Access Compliance Report

(Curb Ramps)

Intersection ID: 53421	Main Street: ARDREY_KELL_RD	Cross Street: MATTHEWS_FARM_LN	Location: SW
ADA ID: CC281F3DD5AC	Ramp Type: Perp	Initial Pass/Fail: Fail	Overall Compliance: No
Severity Score: 13.75			
Codes/Mitigation Info/Possible Solution		Field Measurements/Component Compliance

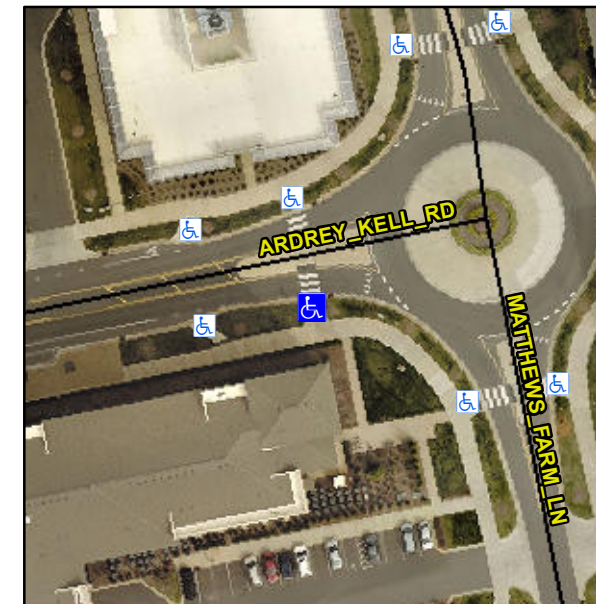
R304.2.2, R304.5.3

Compliance	Description	Data	Compliance	Description	Data
N/A	Ramp Length (in)	139.0	No	Ramp Slope (%)	8.6
Yes	Ramp Width (in)	120.0	No	Ramp XSlope (%)	3.4
N/A	Flare Type LT	N/A	N/A	Flare Type RT	N/A
N/A	Flare Slope LT (%)	N/A	N/A	Flare Slope RT (%)	N/A
N/A	Flare Traversable LT?	N/A	N/A	Flare Traversable RT?	N/A
N/A	Landing Length (in)	N/A	N/A	DWS Provided?	N/A
N/A	Landing Width (in)	N/A	N/A	DWS Contrast?	N/A
N/A	Landing Slope (%)	N/A	N/A	DWS Length (in)	N/A
N/A	Landing X Slope (%)	N/A	N/A	DWS Full Width?	N/A
N/A	Landing Curb? (Y/N)	N/A	N/A	DWS Offset (in)	N/A
N/A	Shared Landing?	N/A			
N/A	Gutter Ponding?	N/A	N/A	Gutter Slope (%)	N/A
N/A	Gutter Lip Ht (in)	N/A	N/A	Gutter X Slope (%)	N/A
N/A	Painted X Walk1?	Yes	N/A	Painted X Walk2?	N/A
	X Walk 1 Direction	To N		X Walk 2 Direction	N/A
N/A	X Walk 1 Width (in)	120.0	N/A	X Walk 2 Width (in)	N/A
	X Walk 1 Slope (%)	1.8		X Walk 2 Slope (%)	N/A
	X Walk 1 X Slope (%)	2.0		X Walk 2 X Slope (%)	N/A

Remove & Replace Entire Ramp.
